AF 289-20 Brighton Avenue, corner of Deblois Street

The appeal under the Zoning Orcinence having been sustained, building permit for construction of a single family dwelling and attached two-car garage at the above lect to the following conditions:

AP 289-295 Brighton Avenue, corn . ' .e. is Street

The appeal under the Zening Ordinance having been sust ired, building permit for construction of a single family dwelling and attached two-car garage at the above location is issued herewith based on plans filed with application for posmit, but subject to the following conditions:-

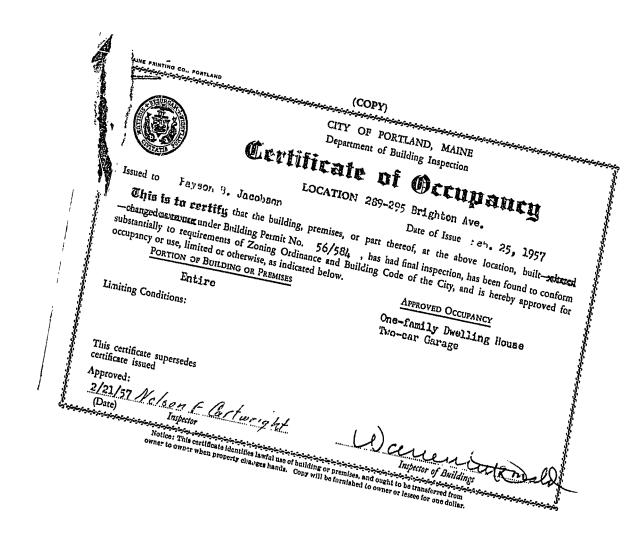
Variances from Months Crainsness requirements on basis of house being numbered on Deblois Street are as follows:-

- 1. The garage would be an unlawful energehant upon the required front yard of the dwelling as execified by work. 168.
- 2. Since the front will of garage is to be only II feet instead of 25 feet back from line of Deblois Street and will be closer to street line than front wall of existing chelling on the adjoining lot, location would be centrary to requirements of Sect. 1586.

Middle we realize that the proposed layout has been designed to fit into the unusual topography of the lot on which the dwelling is to be erected, only the Board of Coulny Argents has sutherity to remait variances from the precise terms of the Ordinance. We are therefore unable to issue a permit for construction of the proposed building in the location shown anless authorization is first secured from that Board. If the owner would like to exercise his appeal rights and will so inform us, we will send him an outline of the appeal procedure and will certify the case to the Corporation Counsel for action.
